Four H Apparels Ltd.

295, Jalalabad, Hathazari Road, Chittagong
(22.405448N, 91.818235E)

20th May 2014

Observations

Slight hairline cracking in beams at Level 1

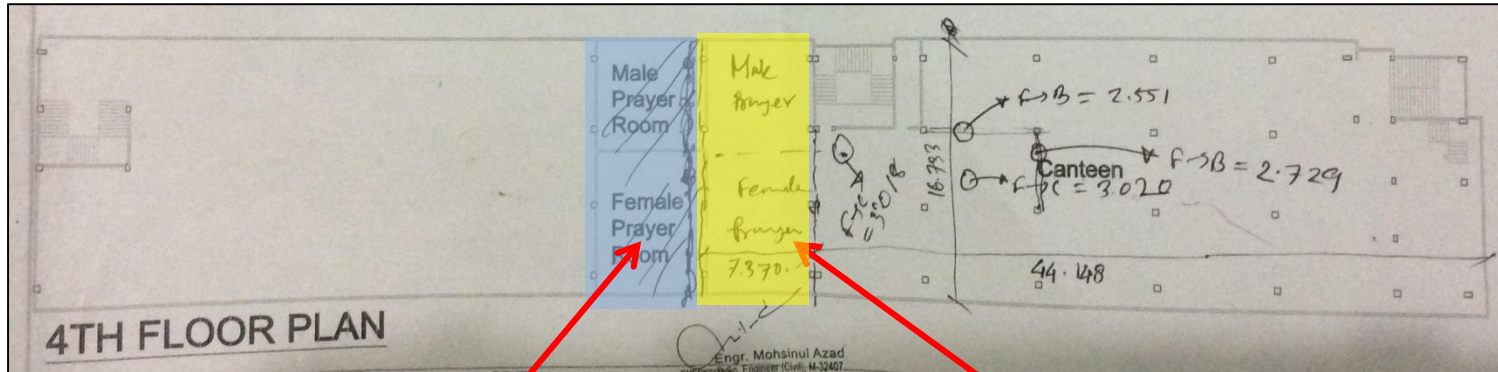
Cracks were visible along one beam on Level 1. These were painted over on one side of the beam, but visible on the opposite side.

Location on
Architectural
Drawings

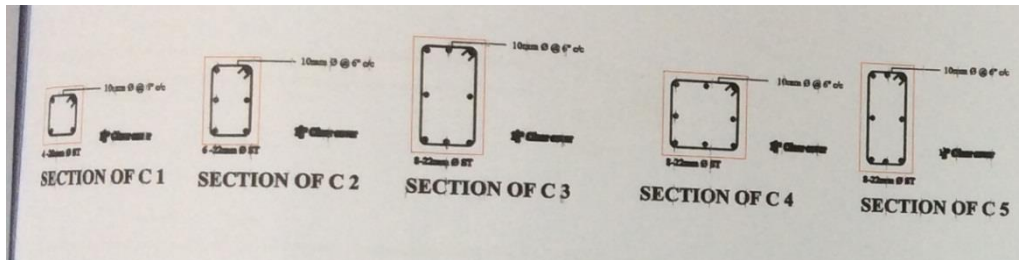
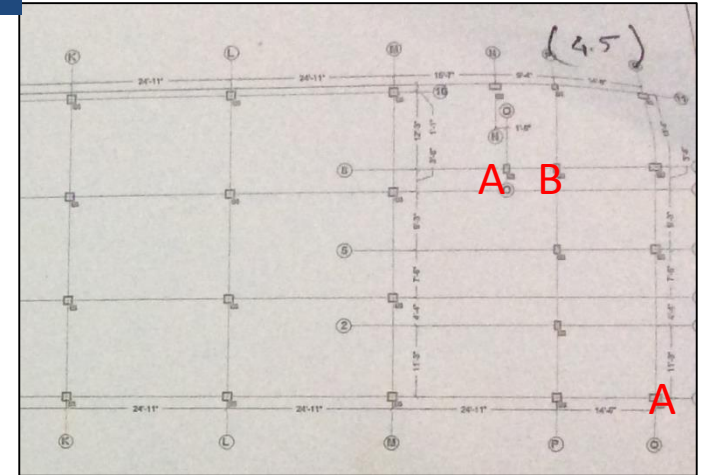
As-built drawings indicate that the prayer rooms on Level 4 are positioned one bay further out onto the level 4 roof area than what was observed.

Original Drawing Column Sizes

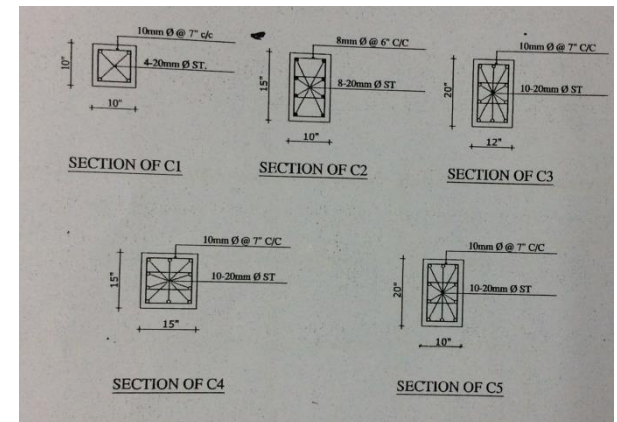
Column layouts did not appear to be entirely accurate – some columns (A) were different size to the drawings, and another (B) was indicated to be orientated in the wrong direction in the drawings.

Column sizes differed between the two sets of structural drawings provided. Reinforcement scanned on site differed from column details shown on drawings.
